PROPOSED LOCATION
OF SHED 6X5 FOR
SIMON J. NEVILL.
BLANDSTOWN HERITAGE
PRECINCT

MEMO

Subject: DA Proposed outbuilding Lot 404 (21) Avon Terrace at BLANDSTOWN

Site Plan

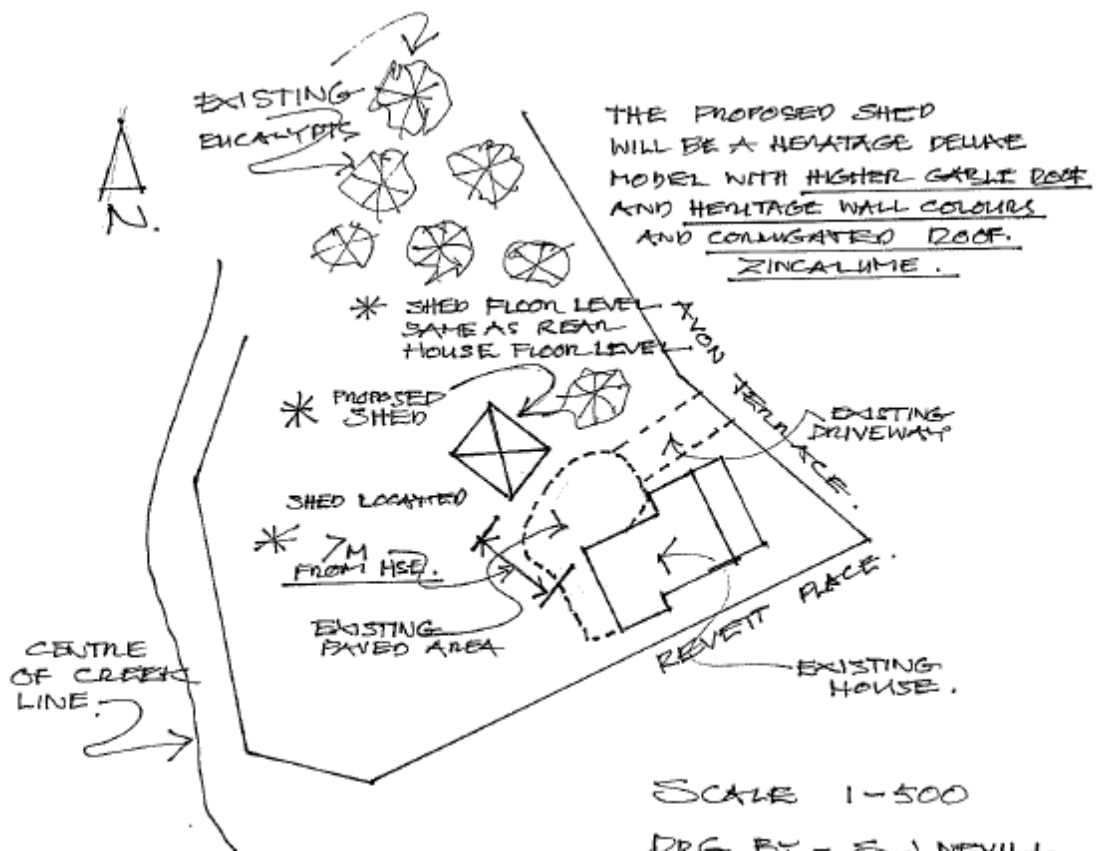
The outbuilding is proposed to be located at an angle to the existing residence and both the Avon Terrace and Revell Place street frontages.

The proposed location is at a ground level lower than Avon Terrace and the same as the rear (lower) section of the existing residence.

The proposal is at an angle to Avon Terrace, the existing residence, and Revett Place. While Revett Place is nominated as the access to the proposed outbuilding, the Avon Terrace frontage is the primary frontage of the site. Although trees partially obscure the Avon Terrace streetscape views of the proposed location, that is not a reliable ensurance, and the site is such that traffic heading south is in direct view due to the bend in Avon Terrace.

Although recognizing the topographic challenges of the site, the Policy emphasises the streetscape issues and the parallel nature of the Blandstown precinct. The existing proposal is not parallel with either street frontage or the existing residence. Given the proposed street access is the secondary frontage of Revett Place, a location closer to, and more aligned to that street front, parallel to the existing residence would be preferable.

Further consideration of the realignment of the location, to be parallel to its Avon Terrace frontage, the existing residence and Revett Place;

Realignment including a location closer to Revett Place to minimize the Avon Terrace impact; and,

Flood Mapping

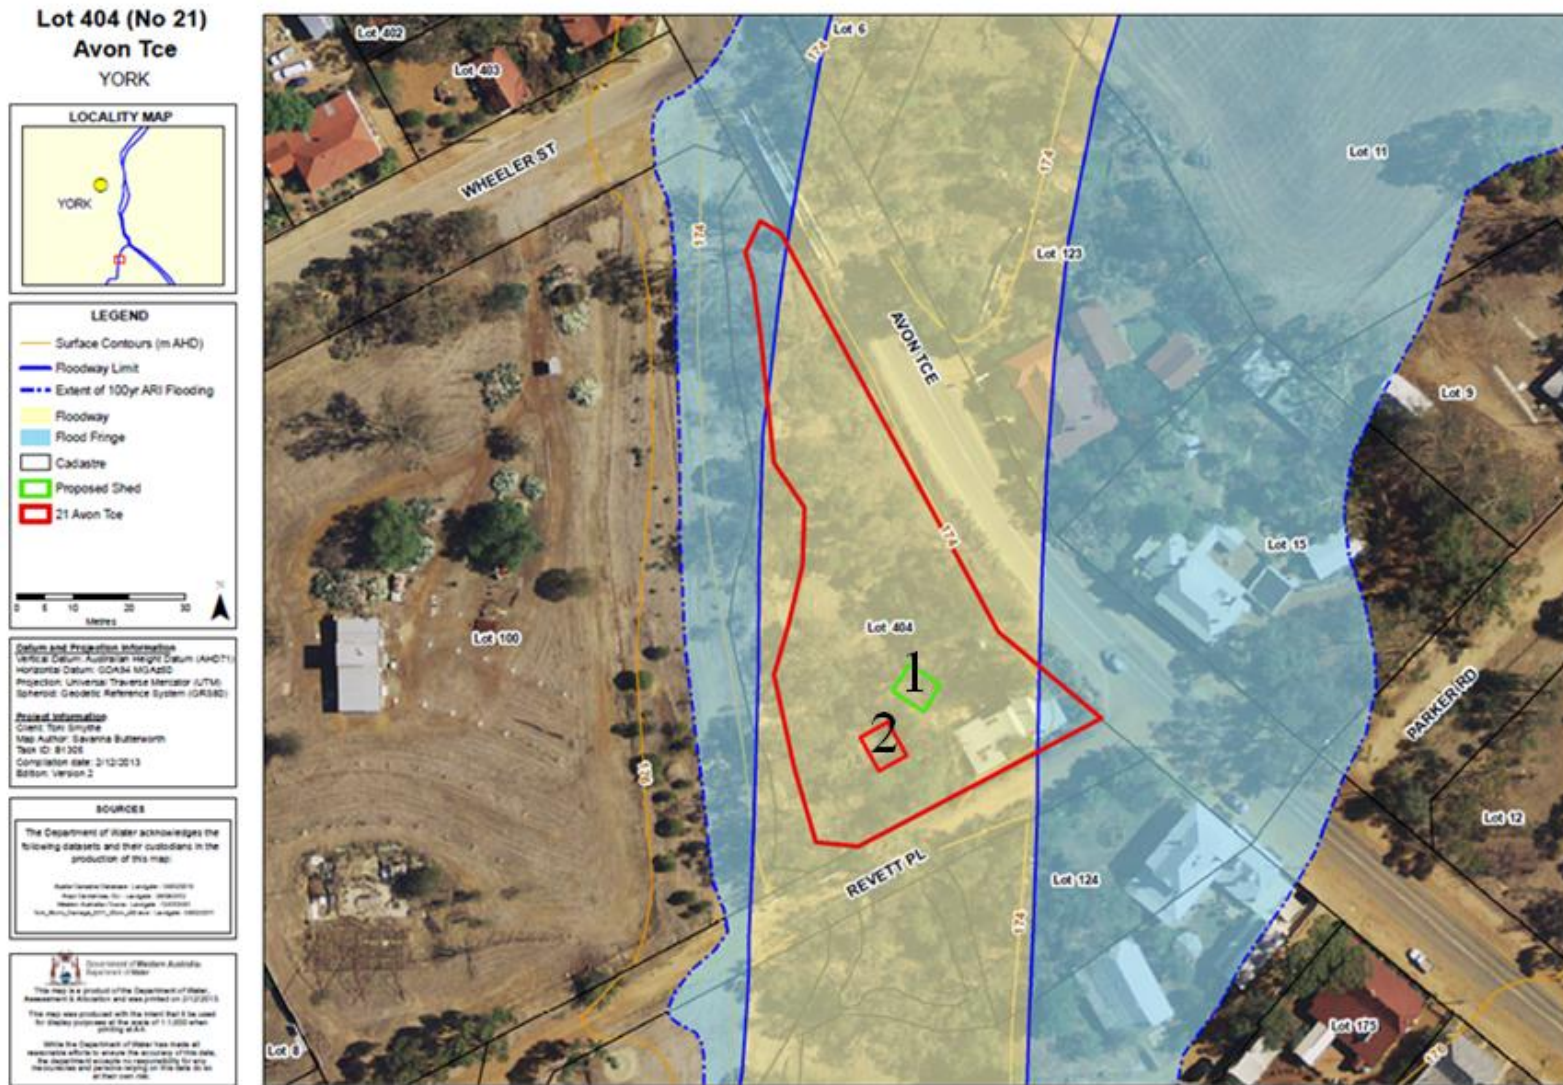
The relocation of the proposed shed moves it much closer towards Bland Brook, increasing the potential for obstruction of major flows in the Brook.

I have attached a copy of the original map you provided me with, with the location of the newly proposed location in red. The shed will be raised no higher than 500mm from the natural ground level.

It is recommended that the proposed shed be located further from the Brook (i.e. closer to the existing house/the original location of the proposed shed).
